### ADDENDUM 1

CSP 22-92

## Cavazos Elementary School Heating & Air Condition (HVAC) Improvements Funded through the Elementary & Secondary Emergency Relief (ESSER) Funds May 31, 2022

## Addendum

Plotted: May 26, 2022, 11:40 AM by user: mcam... Sheet: 6/24/2022 by user: mcam... C:\Users\mgomez\OneDrive\Documents\218007\MD2.11A

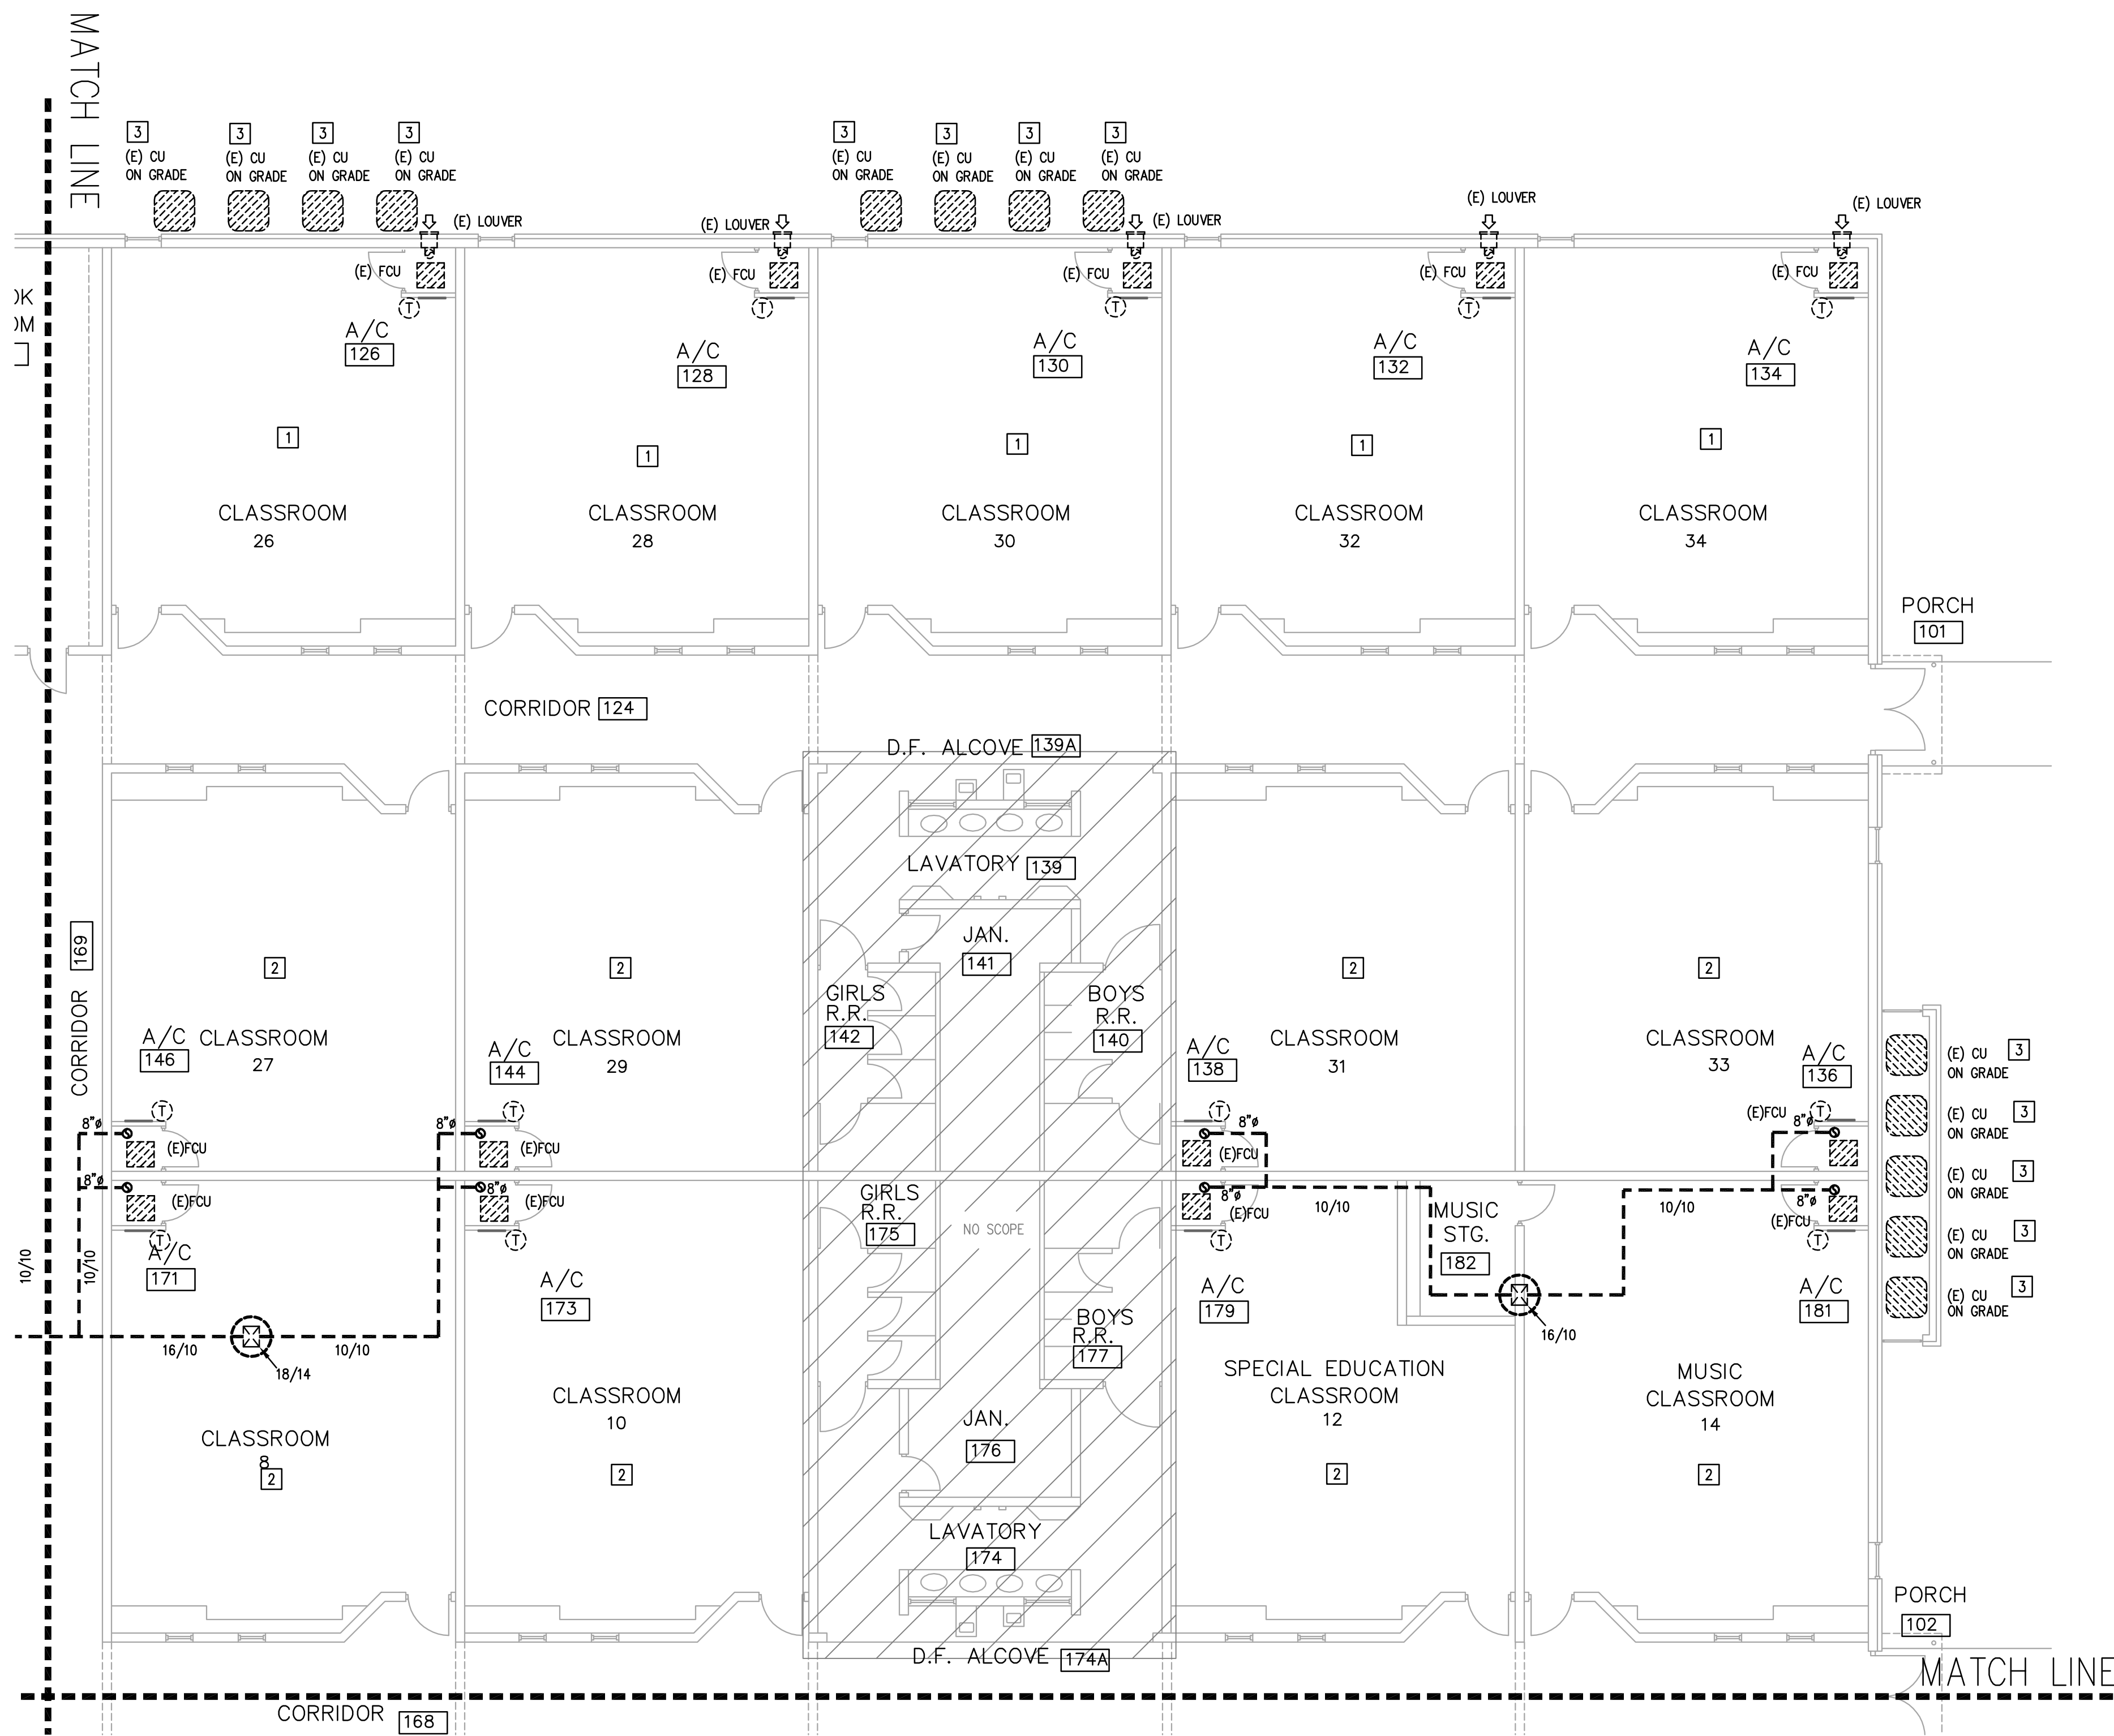
#### Sheet MD2.11A – Level 1 Mechanical Plan – Demolition – Area A

- A. Revised keyed notes 3, 4, 5.

DATE: 05/05/2022  
 DRAWN BY: DBR  
 CHECKED BY: DBR  
 PROJECT NUMBER: 218007.005  
 SHEET TITLE: LEVEL 1 MECHANICAL PLAN - DEMOLITION - AREA B  
 SHEET NUMBER: MD2.12B

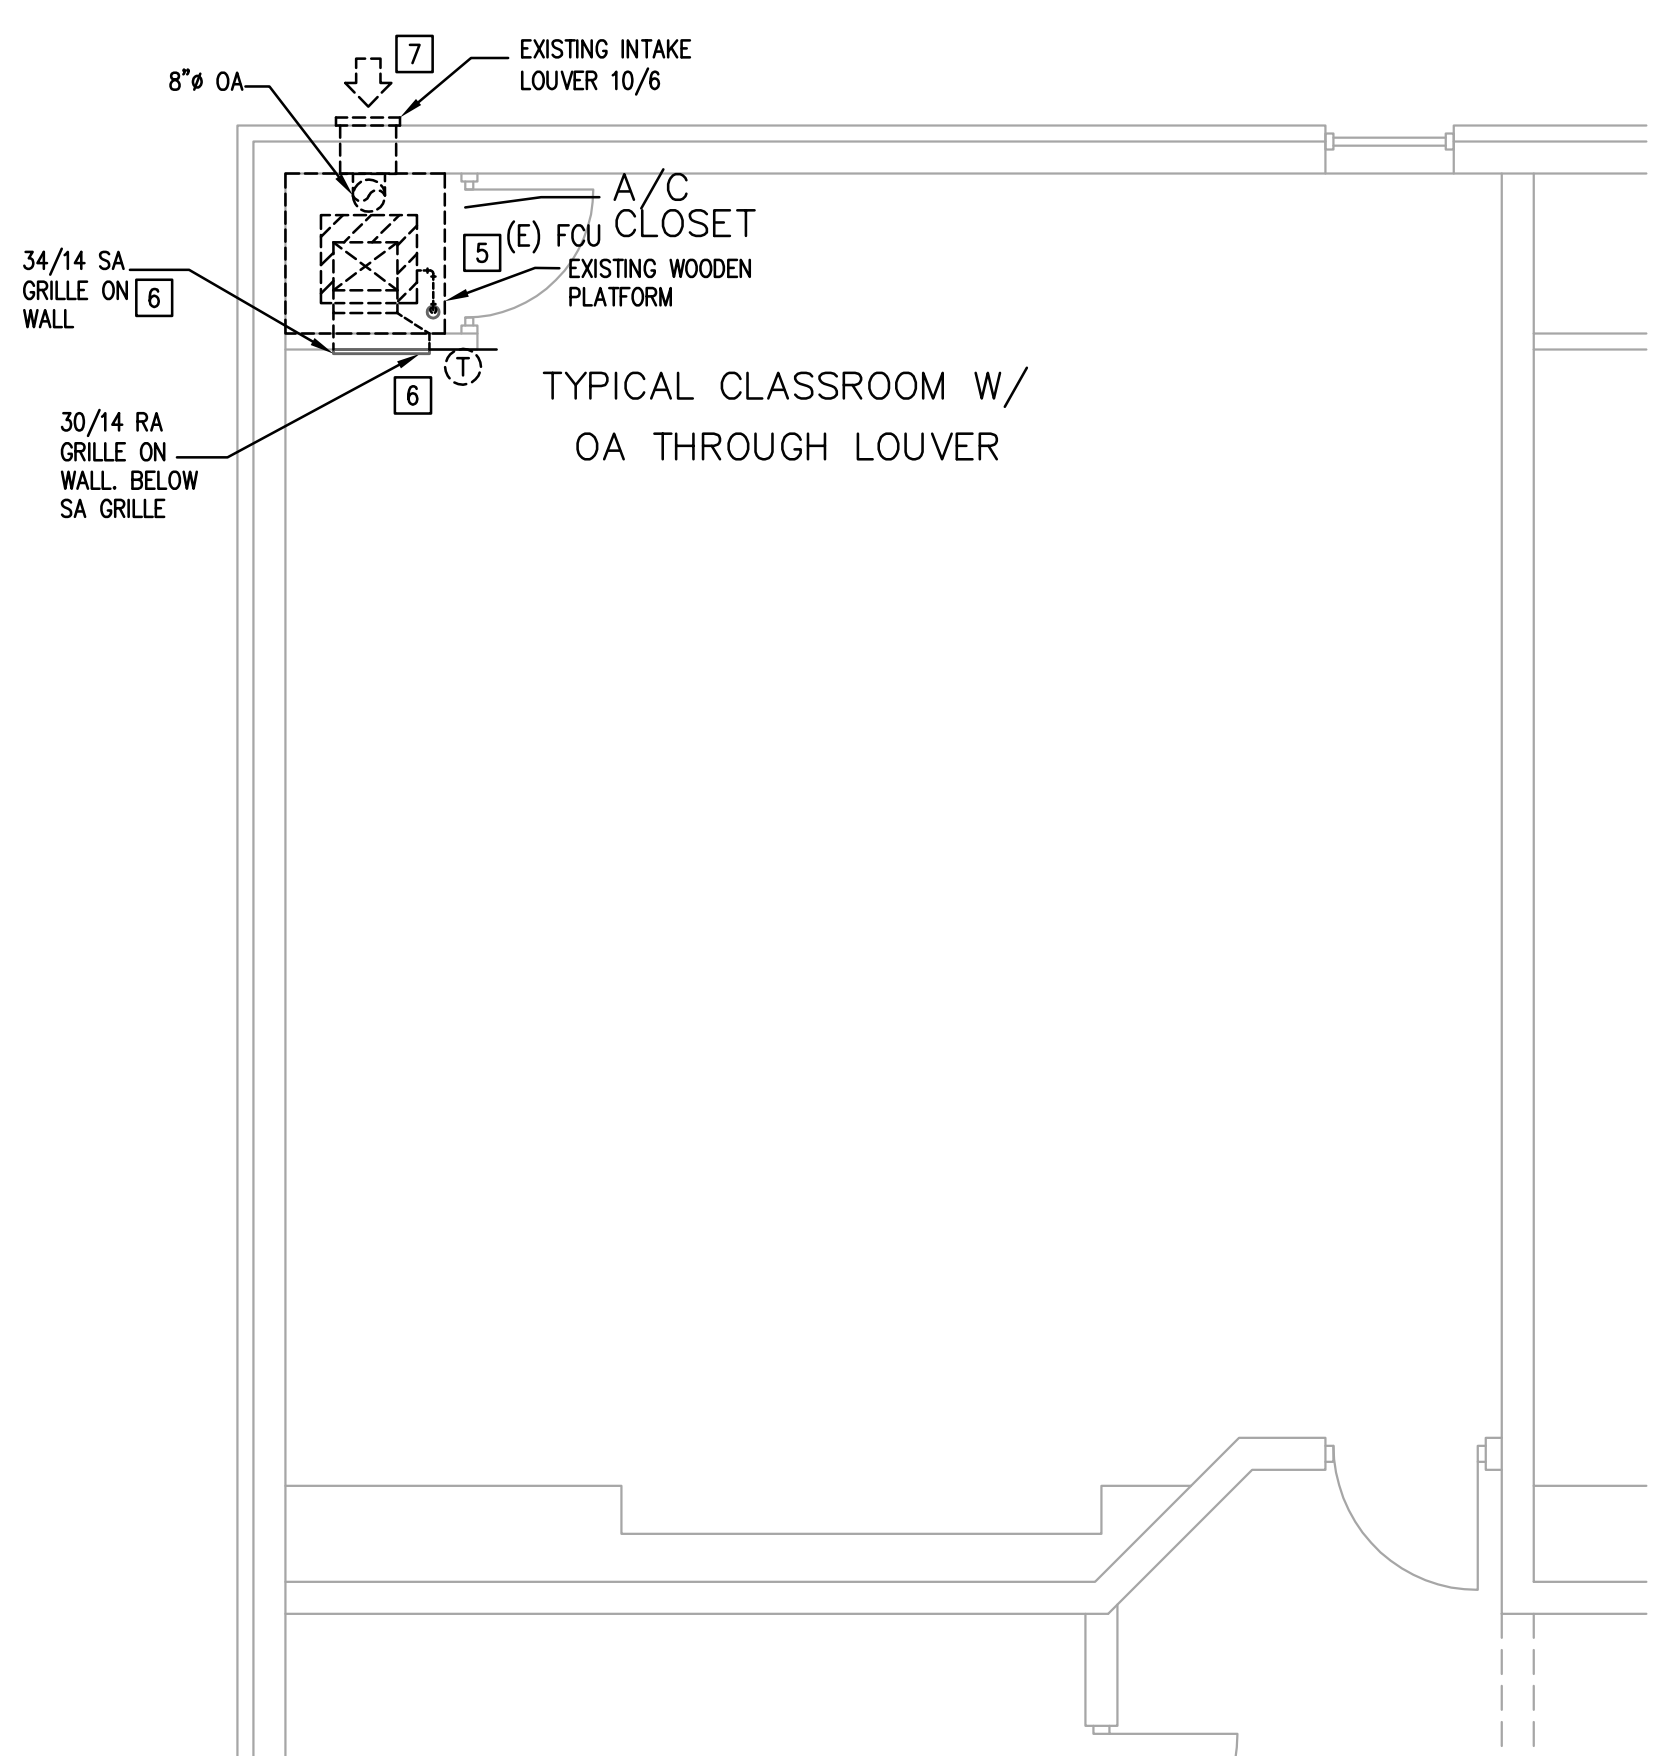
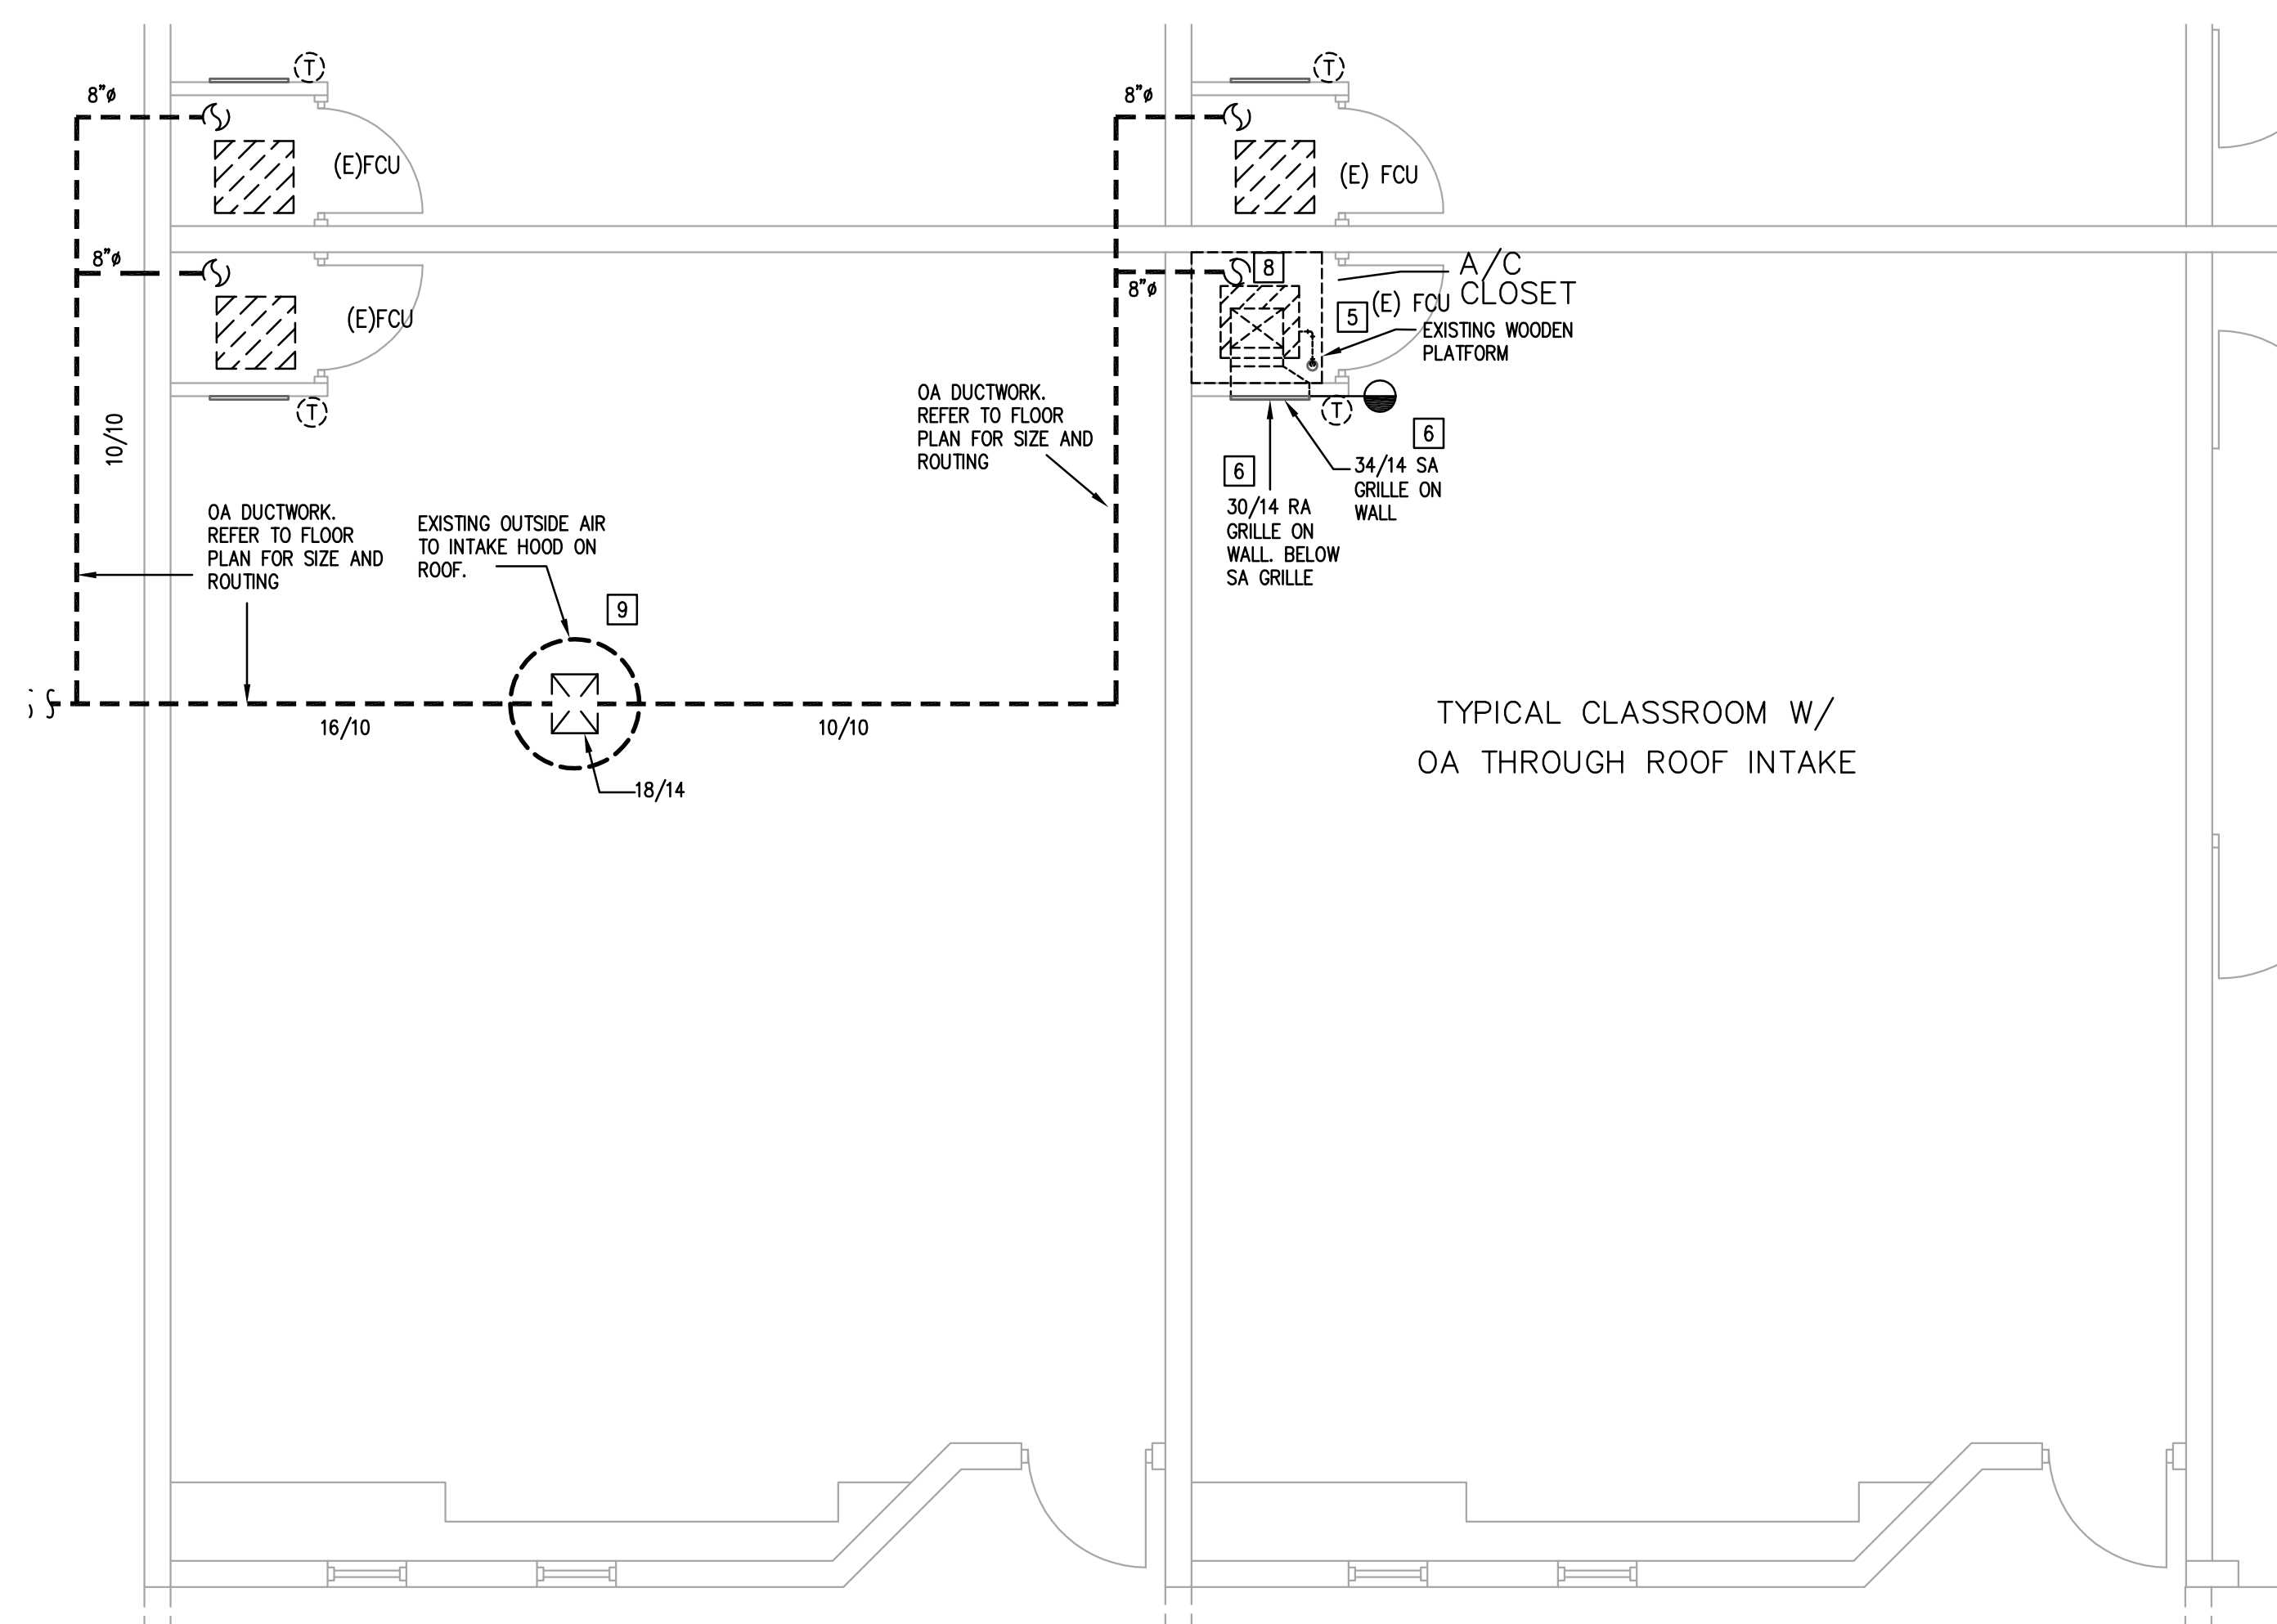
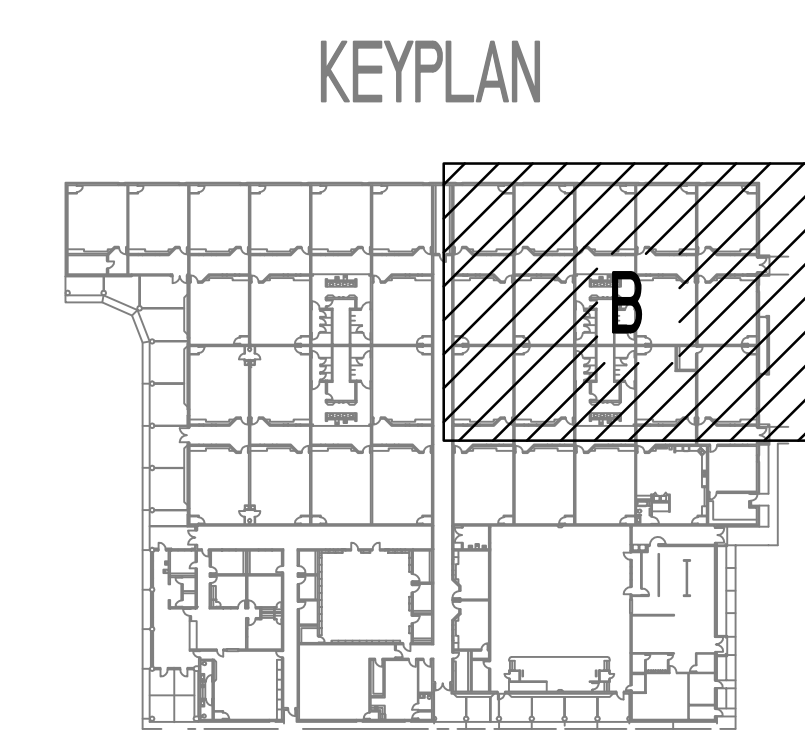
#### MD2.12B – Level 1 Mechanical Plan – Demolition – Area B

- A. Revised keyed notes 3, 4, 5.
